TO: Amy Hodgen  
FROM: Richa Swarup, Blake Farmar Bowers  
DATE: 10.4. 2018  
APPLICATION NO: **PLN17/0703**  
SUBJECT: UD Referral - Precinct 2B Heidelberg Road, Alphington

Urban Design comments have been requested on the

- Public realm and publically accessible areas
- Review of the following documents:
  - Wayfinding signage and Interpretation Strategy
  - Crime Prevention through design

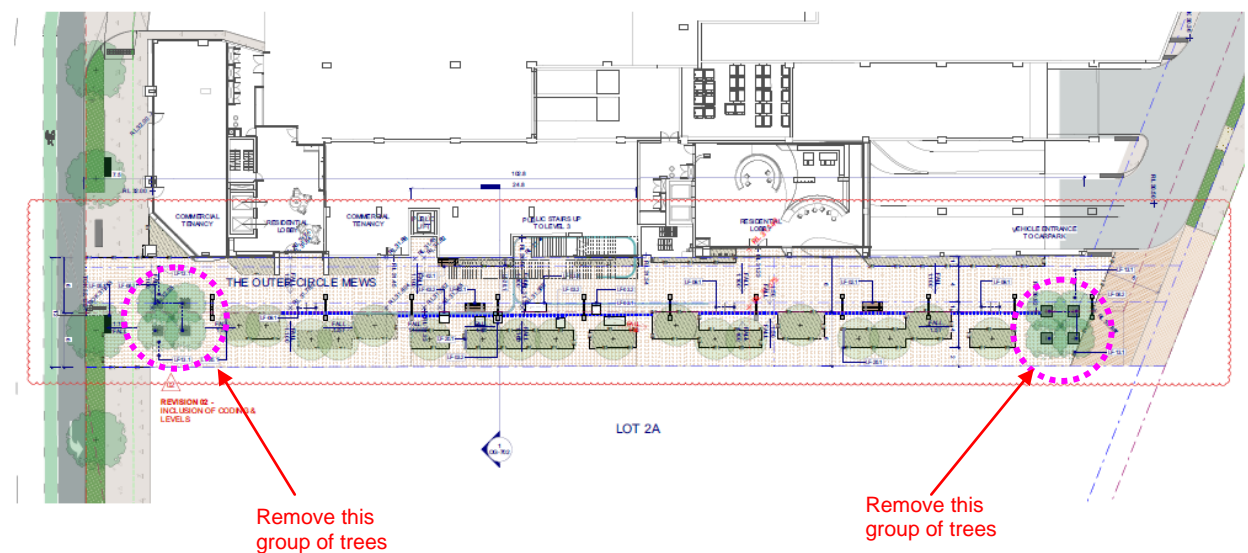
The functional layout (TP-LAN-OG-102 -02) as above includes a row of trees aligned, along precinct 2A. Other elements such as brick plinths (platforms), timber sleeper seats, lighting and bike hoops are also included in the middle and eastern area along the line of trees. The layout thus appears very busy with lots of residual spaces in between. This concept needs to be simplified. Following suggestions are being made to improve this layout

- Improve the grouping of various elements avoiding small residual spaces. Consider shadow diagrams whilst deciding the locations so that at least 125 sq. m are receives solar access between 9 am and 3 pm.
- Avoid placement of trees near the entrance that block the fire and emergency clear zone alignment. Heidelberg Rd copse straddles MFB clear zone alignment (adjacent area available). This may reduce legibility of pedestrian link.
- Consider using longer seats instead of small squares. There is also variation in heights between brick plinths and timber sleeper seats (p58 Render). Consider standardising heights to reduce difference in both form and materiality.

- Seats may be desirable for BMX peg grinding. Consider coping/ deterrents when detailing.
- The colour of the brick plinths should be different from the brick pavement to make the horizontal and vertical surfaces visually distinct.
- Bicycle hoops are supported however may need to be relocated as the locked bicycles may obstruct MFB access. Allow 1.8m long clearance (400mm each end of hoop) whilst deciding new locations.
- The idea of installation of wind screens is not supported as it may affect the sightlines.
